**RE: Value Planning Study Final Report – Comox Valley Water Treatment Project**

# Value Propositions Implementation Response

# Value Planning Study

Alternative No.: IR-23

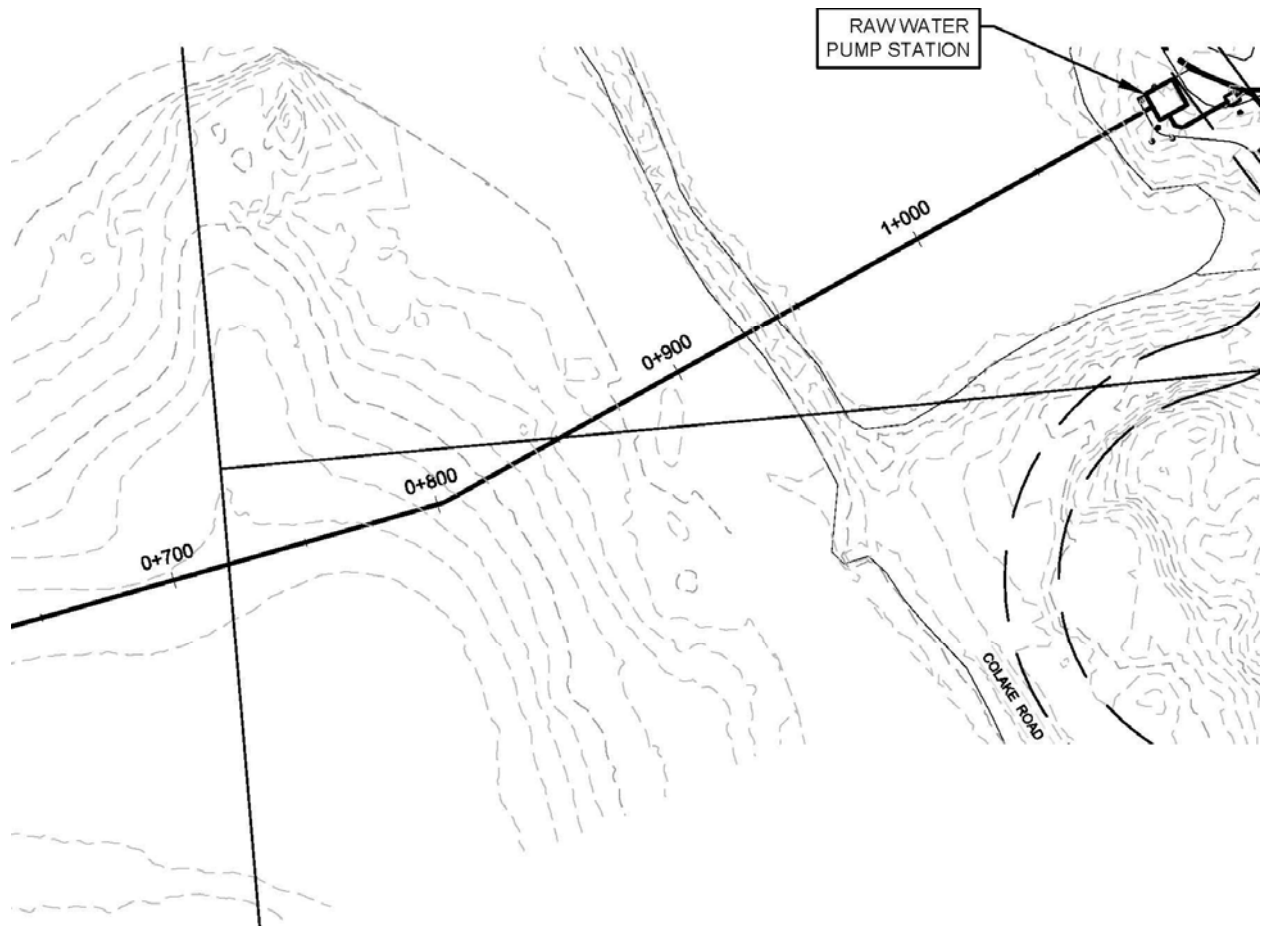
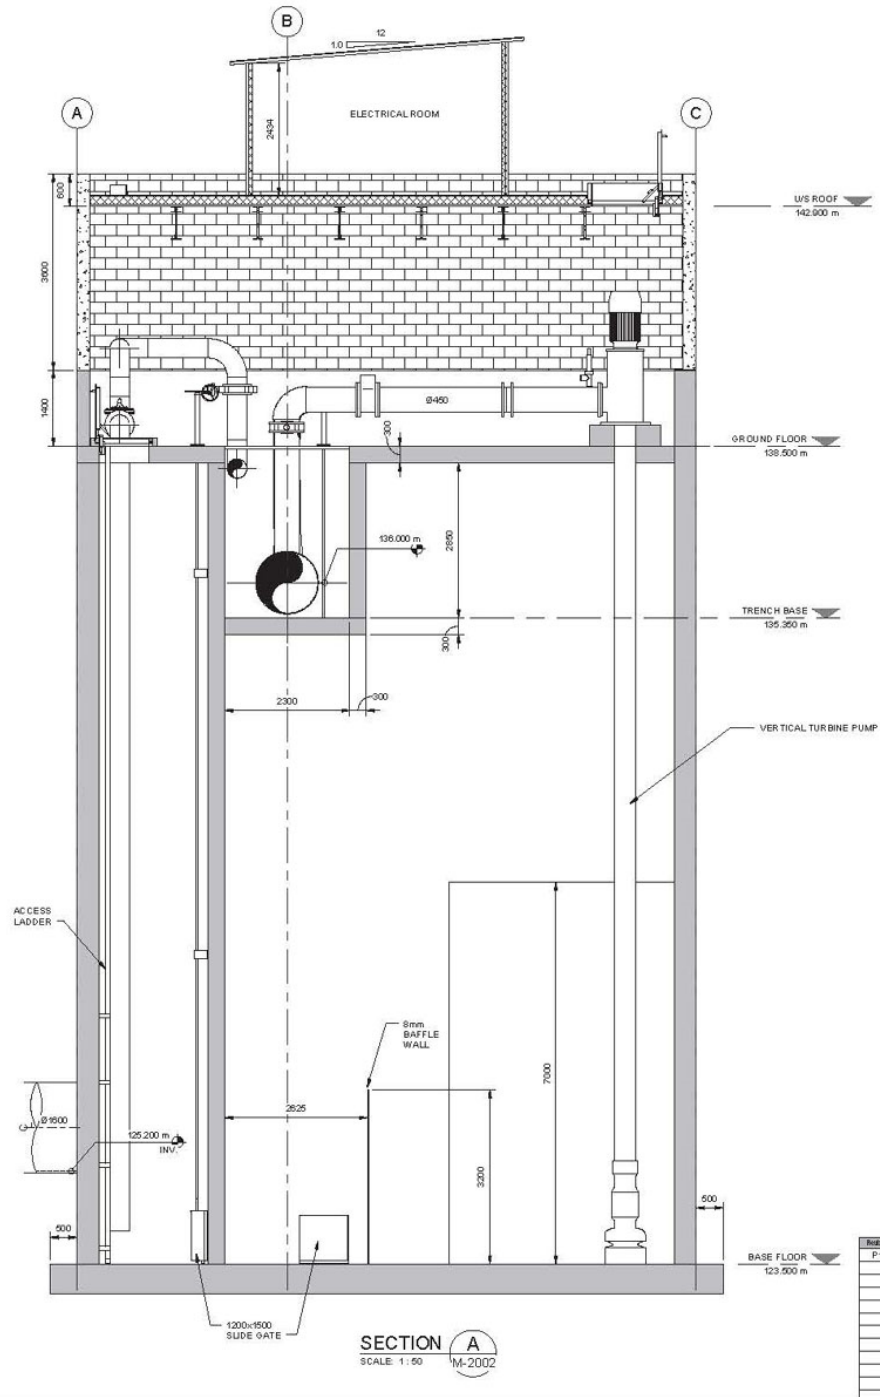
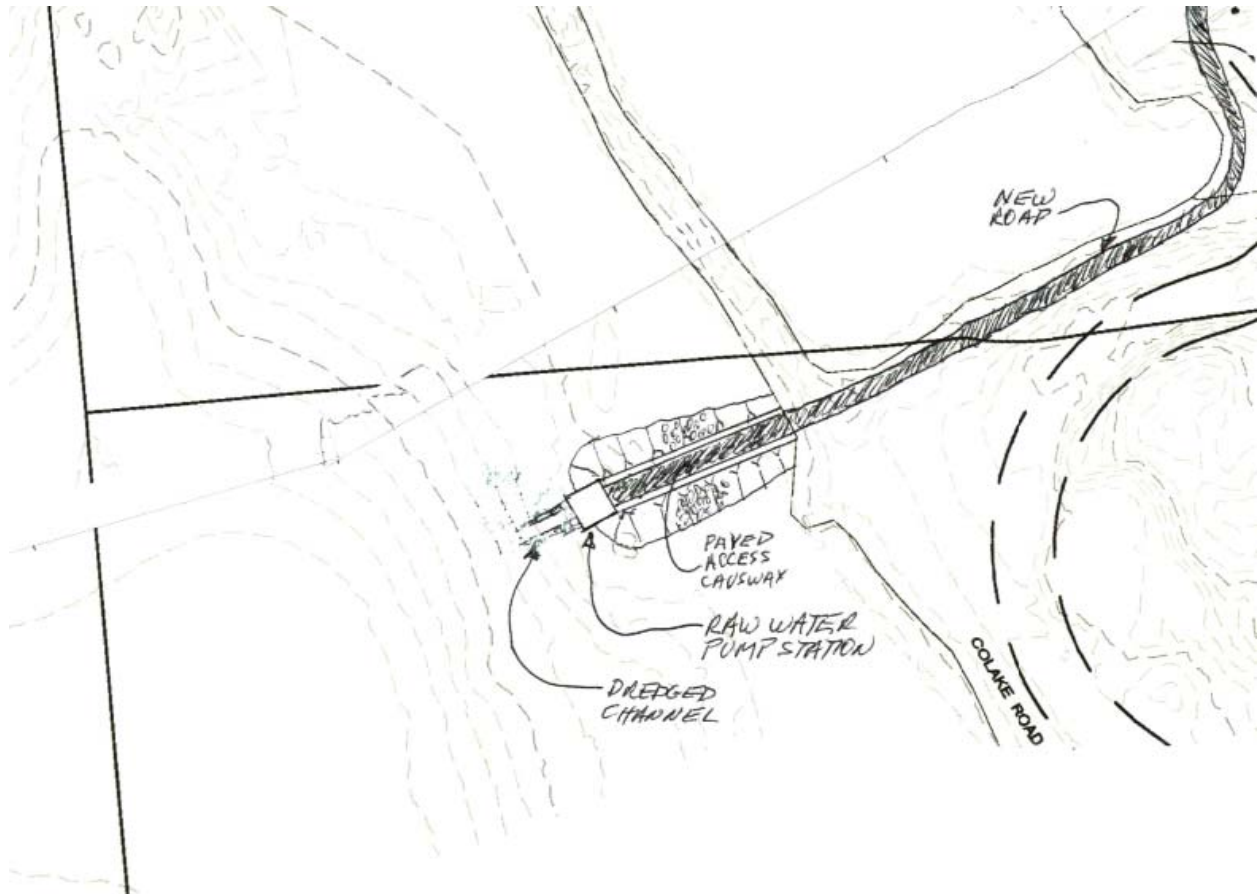
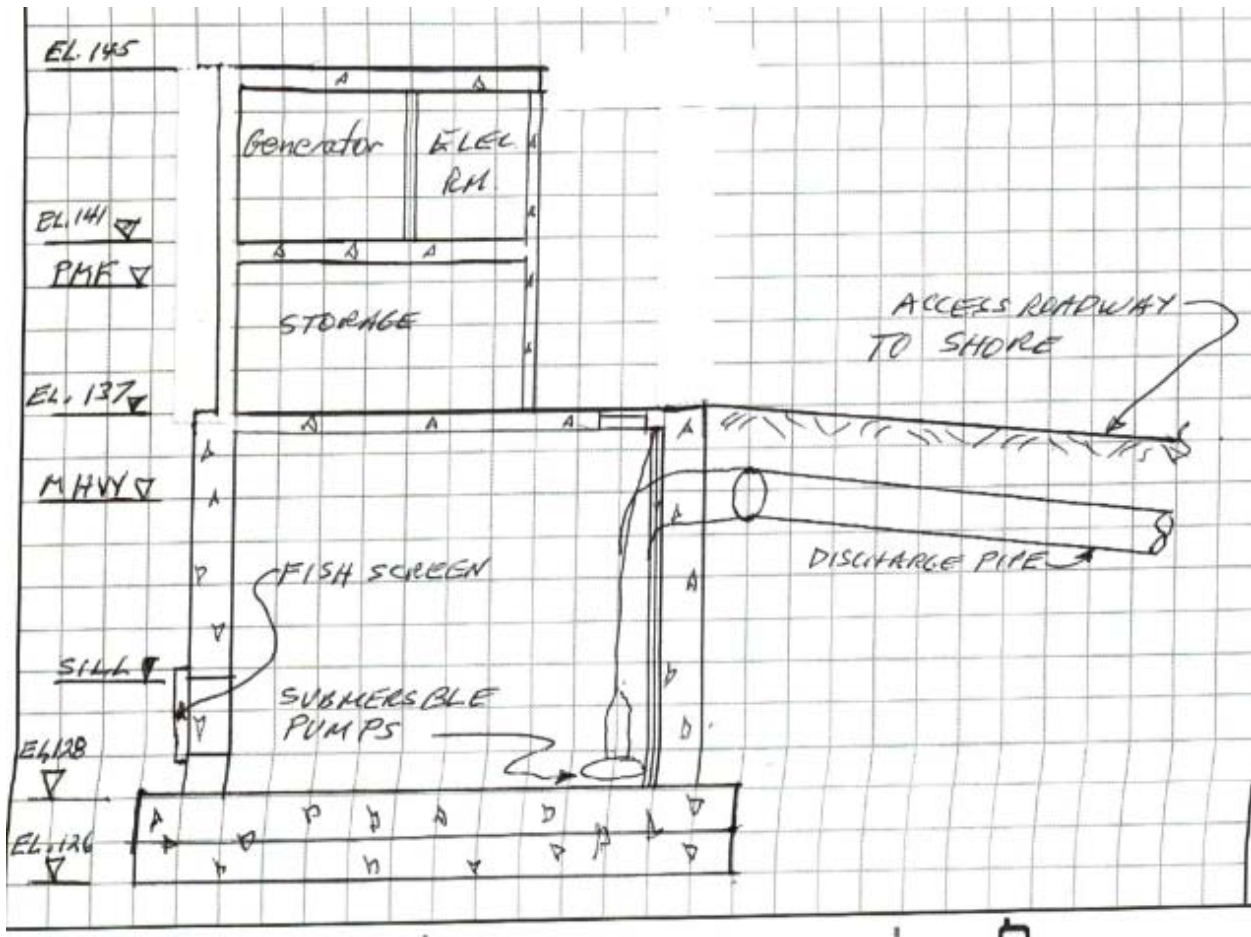
Access to the station would be via an approximately 65 m long earthen causeway, with an asphalt-paved eight-meter roadway. The causeway would use rip rap to minimize erosion. A new roadway would be required across current Rod and Gun Club land adjacent to the lagoon. For this alternative, it has been assumed to be at approximately the current ground elevation. With further review, it may be necessary to raise this roadway, if not above normal lake operating levels.

An entrance channel would be dredged to the lakeside face of the pump station. For this analysis, the bottom elevation of the channel has been assumed to be at EL126.

Alternative No.: IR-46

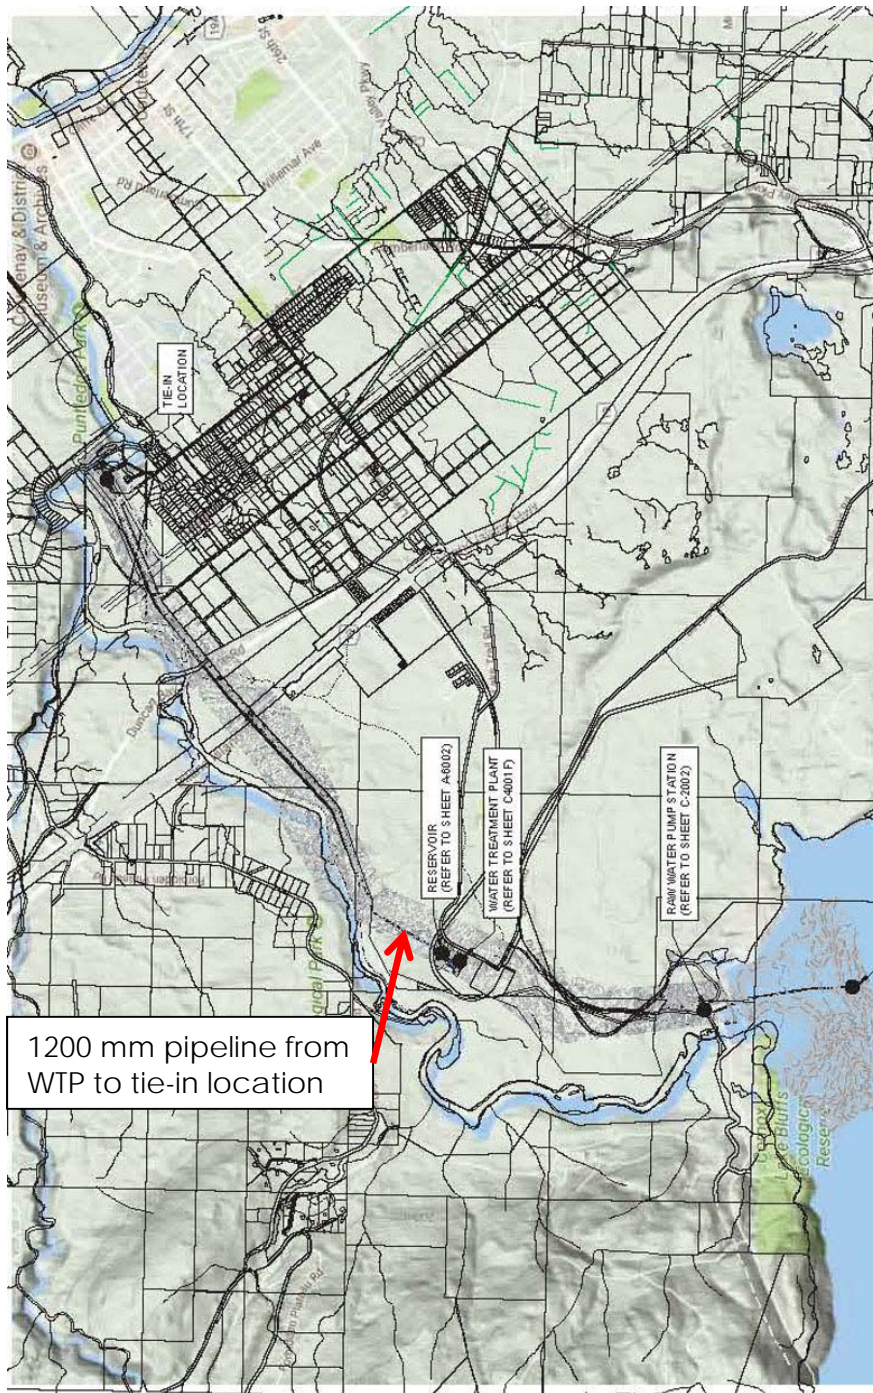
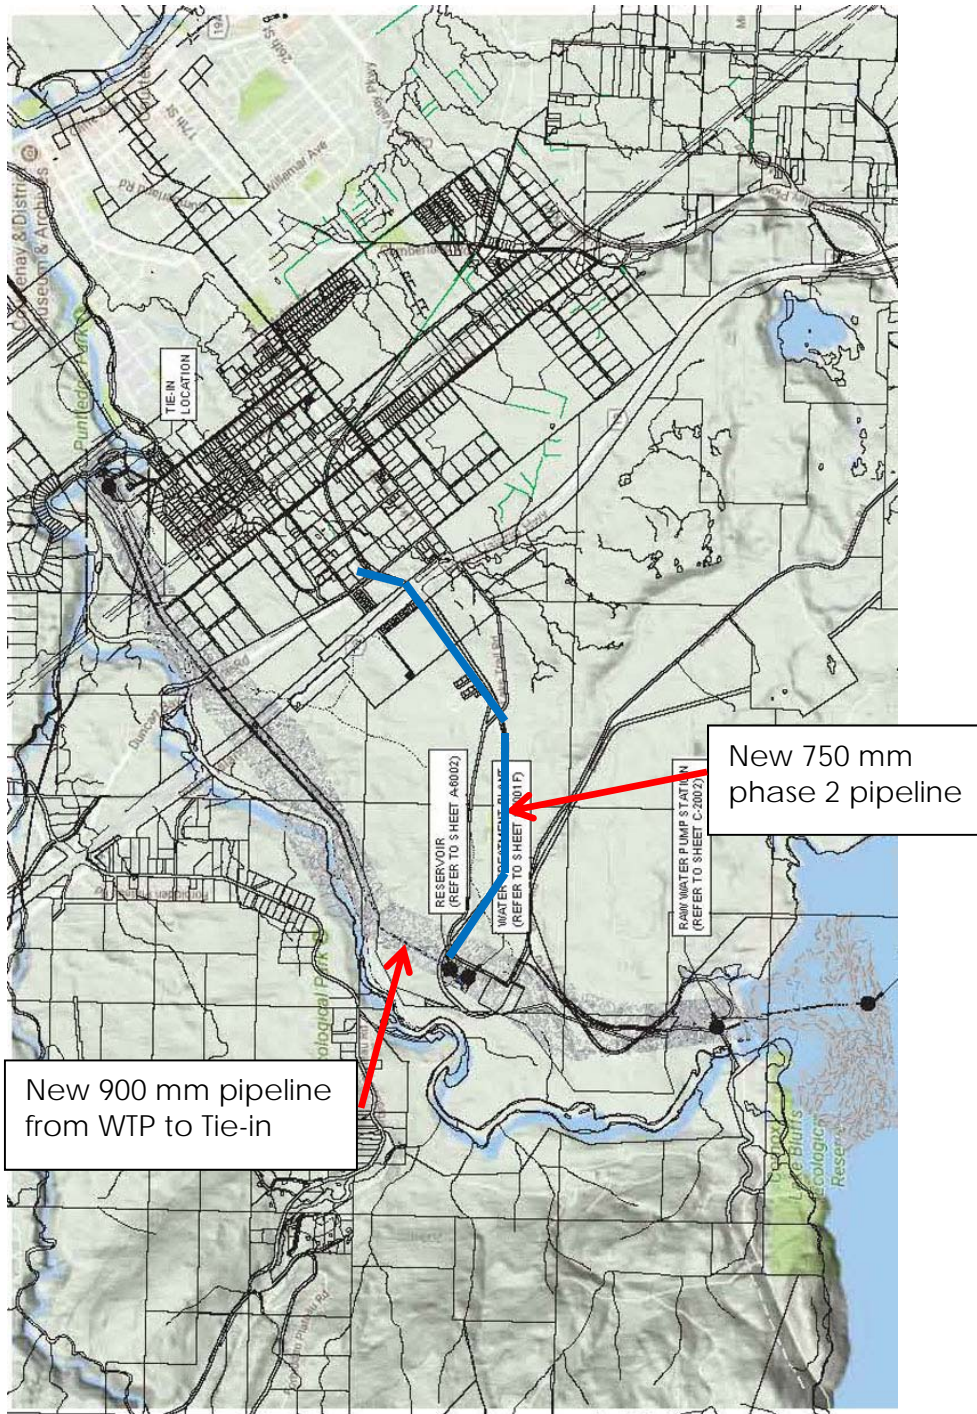
The original design installs the 100-year required transmission capacity in the current project and delivers all of the flow to the distribution system and the current delivery point.

The alternative installs approximately 67 ML/d of transmission capacity along the currently planned alignment initially and defers installation of the additional transmission capacity until later, deferring the cost of added transmission capacity to the future, when additional customers are available to share the cost. The second transmission pipeline would add approximately 47 ML/d capacity (assuming the same allowable headloss per meter) in the future and deliver that water to a different location in the distribution system. This approach limits transmission capacity in the initial years but provides substantial transmission security once the second pipeline is built. For the purpose of this analysis, we have assumed that the pipeline could be installed adjacent to the existing roadways (some of which are timber company roads) by conventional trenching but would be installed with a directional drill through the Morrison Wetlands area. For costing, both pipelines have been assumed to be steel, but it may be possible to construct the second using HDPE, provided pressures are not excessive along the second route.

This alternative suggests replacing the single 1200 mm treated water transmission pipeline with a 900 mm pipeline on the original alignment and, when required, construct a second 750 mm pipeline on a new alignment. This essentially defers the capital cost, and provides redundancy in the future. This will save capital costs between \$2 million (WSP estimate) to \$5 million (VP report) in the short term and provide redundancy when the second pipeline is built. However, this option will have a higher present value cost to the project of between \$9 million (VP report) and \$13 million (WSP estimate) due to the construction of the second pipeline.

The savings for the treated water pipeline size reduction is less than what was indicated in the value planning report since the material costs normally accounts for only about 1/3 of the overall installed cost. This staging alternative is rejected.

Alternative No.: IR-51

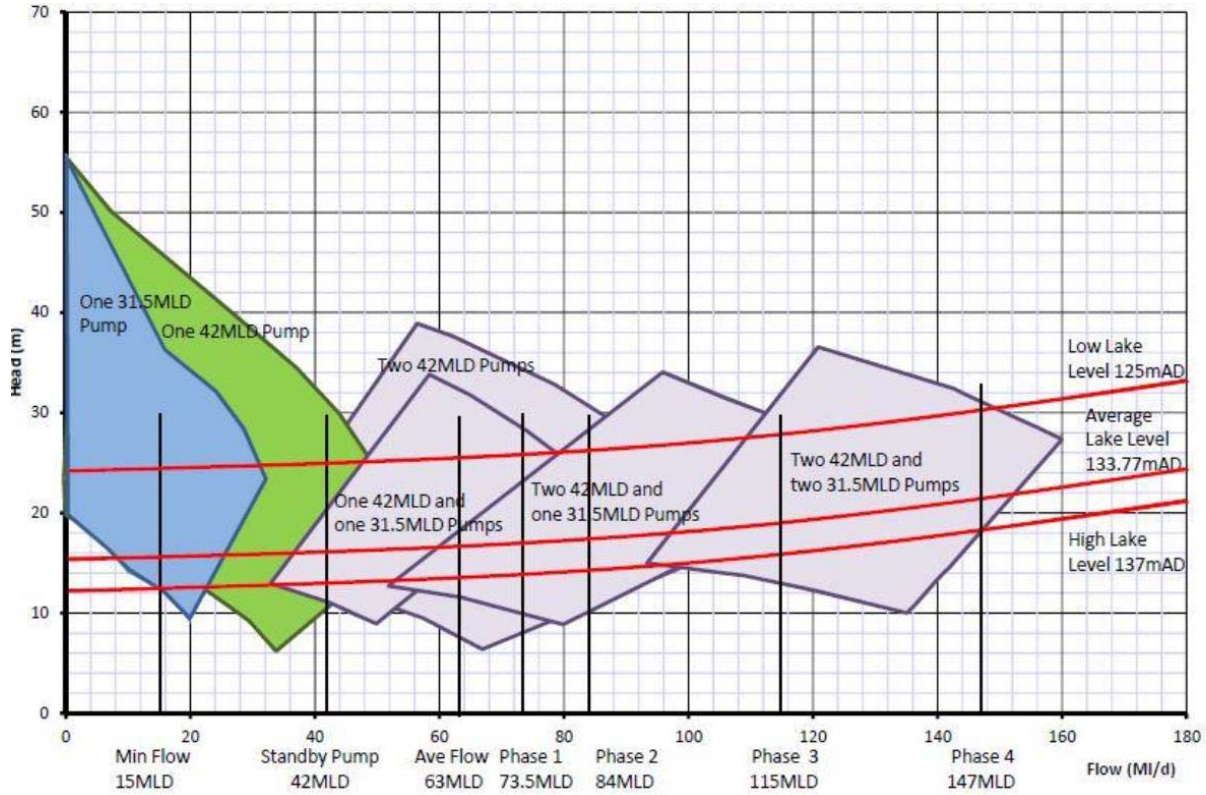
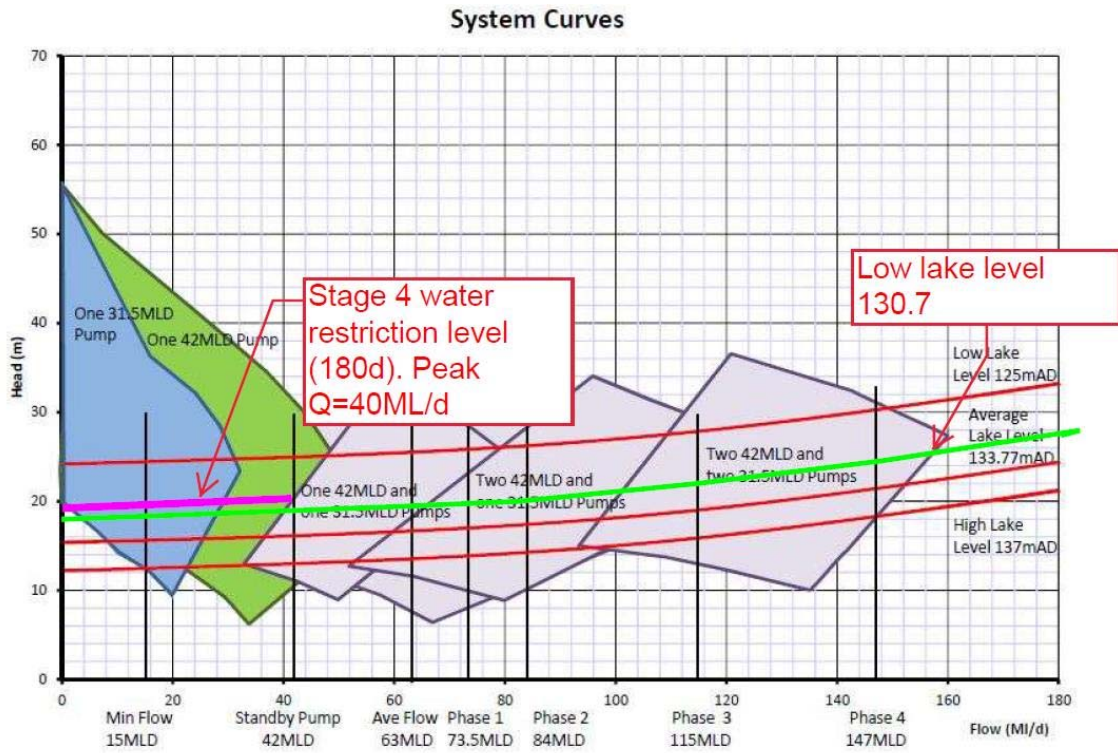
**Pump Horsepower.** Pump horsepower changes from those assumed in the documents for the following conditions.

1. Stage 4 Flow Restrictions. Two pumps (one standby) of 40 ML/d at a head of 15.3 m yields two pumps at 120 hp (125 hp nominal.) These could be fixed speed pumps.
2. Normal flow conditions. Three pumps at 47 ML/d are required for ultimate flow of 143 ML/d, with three pumps at 200 hp. One additional pump would be installed for standby. These should be variable speed pumps.
3. Total installed horsepower would be 850 hp.

The alternative pumps proposed by the value planning team assumes a higher minimum level in the lake of 130.3 and incorporate fixed speed pumps. The fixed speed pumps cause supply gaps at the initial minimum flows and compared to the original design and would necessitate flow control at the WTP (e.g. a modulating control valve).

When Stage 3 restrictions are imposed at EL 130.7, a flow restriction of 40 ML/day is assumed – which may not be valid if fire flows were to take place. However, the system curve will be updated to show that at minimum lake levels the normal flow will (in practice) be lower – creating a zone in the system curve where pump efficiency requirements could be relaxed thus achieving some potential for cost savings. The use of fixed speed pumps is rejected.
